SERVICE LETTER #39

SUBJECT: Belly Stringer Forward Attach Angle

Figure 1
Revised Belly Stringer Installation

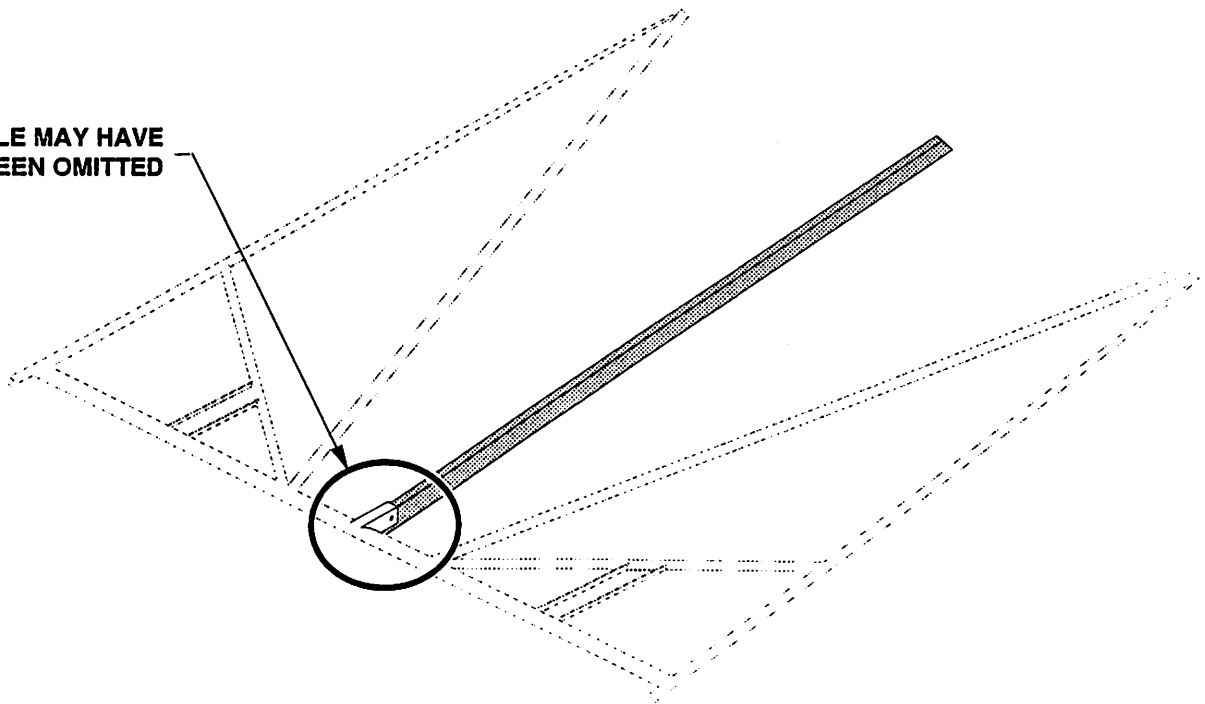
Some Series 5 Vixen fuselage weldments may have been shipped without the forward belly stringer attach angle installed. Inspect your fuselage for the presence of the attach angle, and if you do not have it, you can still easily attach your belly stringer without modifying the fuselage. The drawing on the next page shows the angle that is the subject of this letter, and the different steps for installing the stringer.

THIS ANGLE MAY HAVE
BEEN OMITTED
